Jones Associates 5/29/15
 R-T.

21 Dalton - Silas Canavan
 - Walsh Engineering

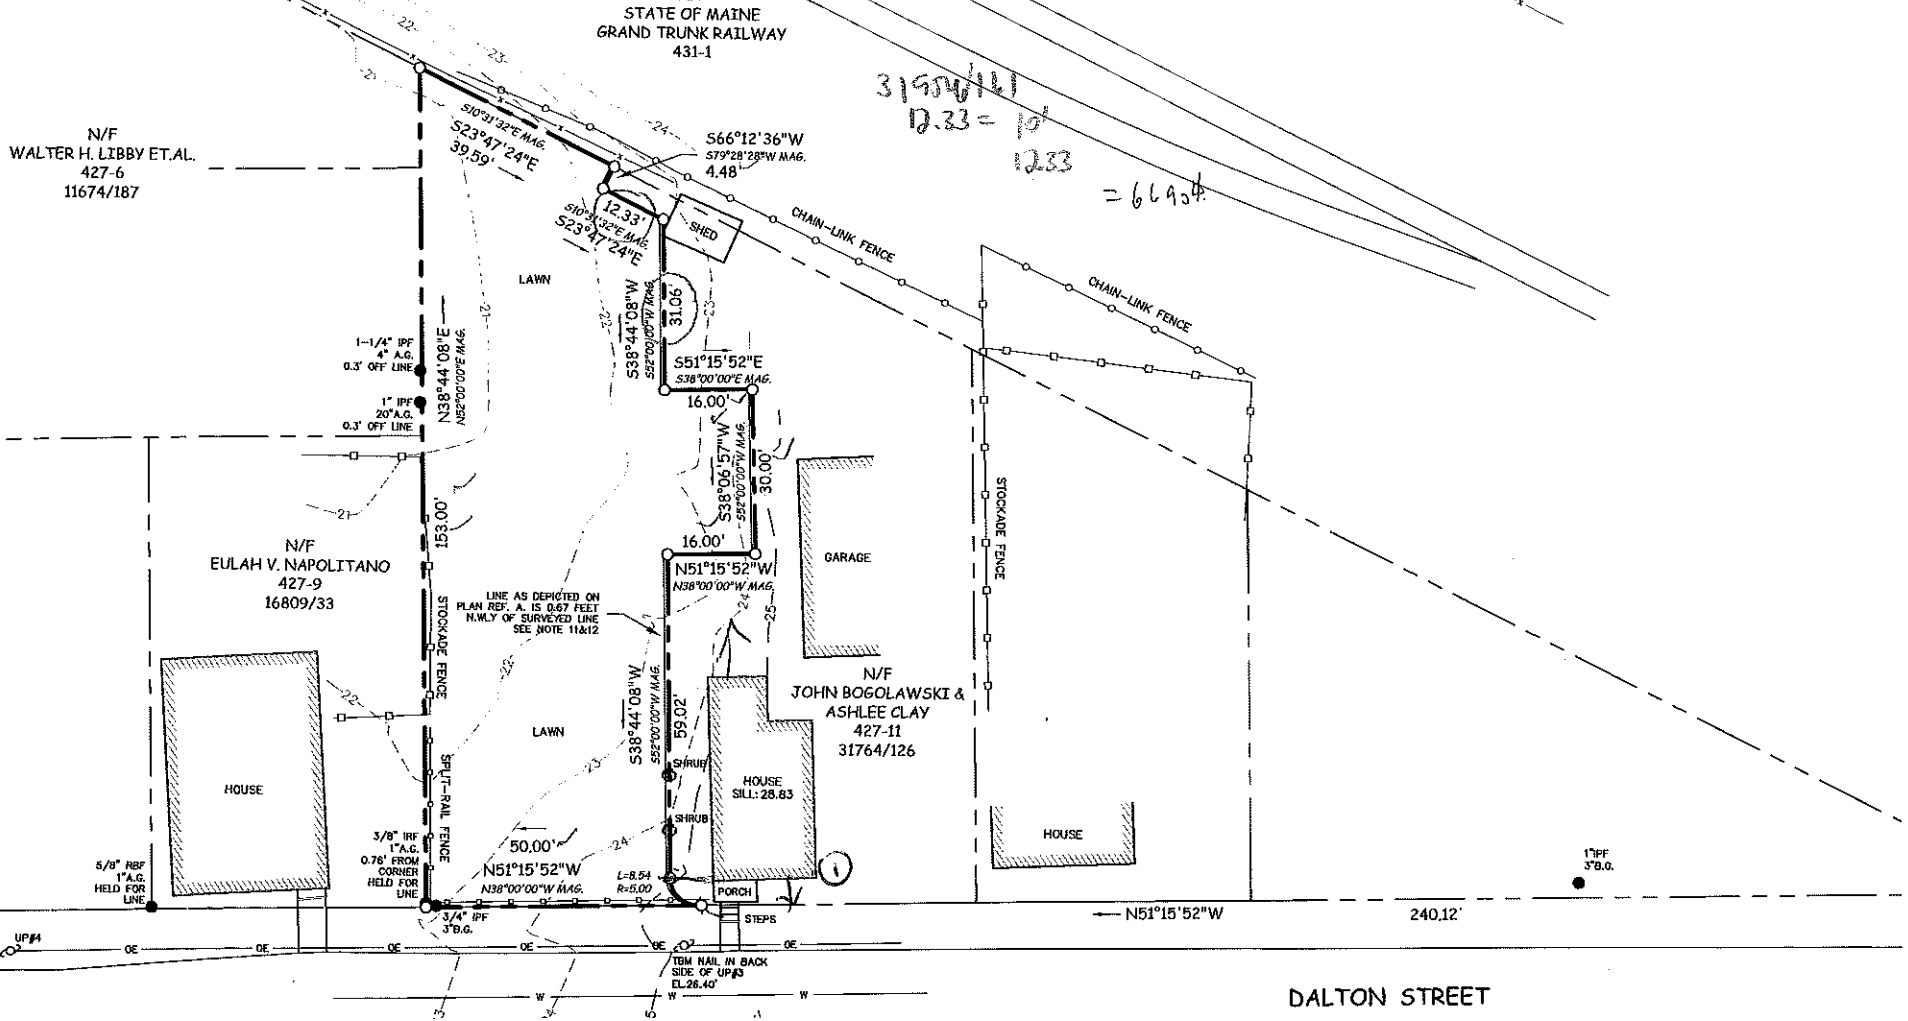
*with proposed building decks! not to be covered

*-part have parcel sold nonconforming lot

-shed not as needs to be relocated

- ① need 60' lot width
- ② porch part of part of lot width

31900/141
 12.33 = 10'
 12.33 = 66.954
